**CNC SYSTEM FOR MACHINING CENTERS****YASNAC J50M****UPGRADING FUNCTION MANUAL**

Thank you for selecting YASNAC J50M. The YASNAC J50M upgrades the specification of several functions.

This manual describes the function upgrades and how to handle them.

Fig. 2.1 At-reference-point Output Signal

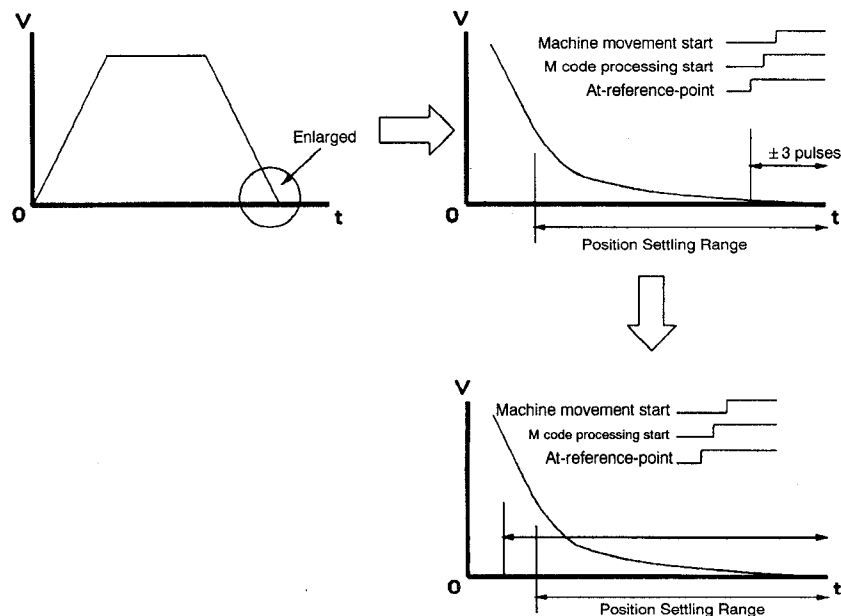
For this evaluation, YASNACJ50 normally uses the “at-reference-point” output signal, one of the signals output by the NC. Because the signal output range is fixed at  $\pm 3$  pulses relative to the zero point, the signal can only be used as a “complete output (COIN)”, not as a “near-zero-point (NEAR)” output.

However, the upgrade makes the “at-reference-point” output signal variable so that it can be used as a “near-zero-point (NEAR)” output. Although the positioning settling time remains unchanged, a reduction in cycle time of several hundred milliseconds is possible because machine movement is enabled during the settling time instead of after it is complete.

The “at-reference-point” signal is output when the axis is within the range set by the parameter relative to the zero point.

The range reverts to the original 3 pulses (fixed) if the parameter is set out of range.

When used as the start condition for automatic coordinate system set-up after zero point return is complete, the range remains the original 3 pulses.

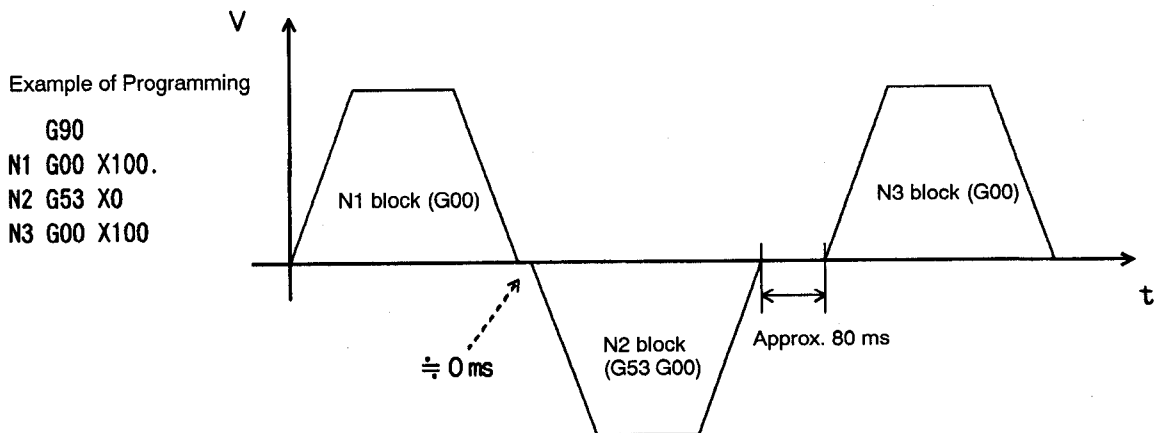
Fig. 2.2 shows the X-axis feedrate waveform during G00 block program execution when the selection parameter is set to “No in-position wait” (pm6018 D3 = 1). Despite the parameter setting, in-position waiting occurs in the G53 block, resulting in approximately 80 ms stop time between blocks.

Parameter No.	Bit No.	Description
pm6074	D0 = 0	In-position wait during execution of G53 block
	D0 = 1	No in-position wait during execution of G53 block

In the G01 mode, the execution mode of a G53 block is set by the pm6018 D3.
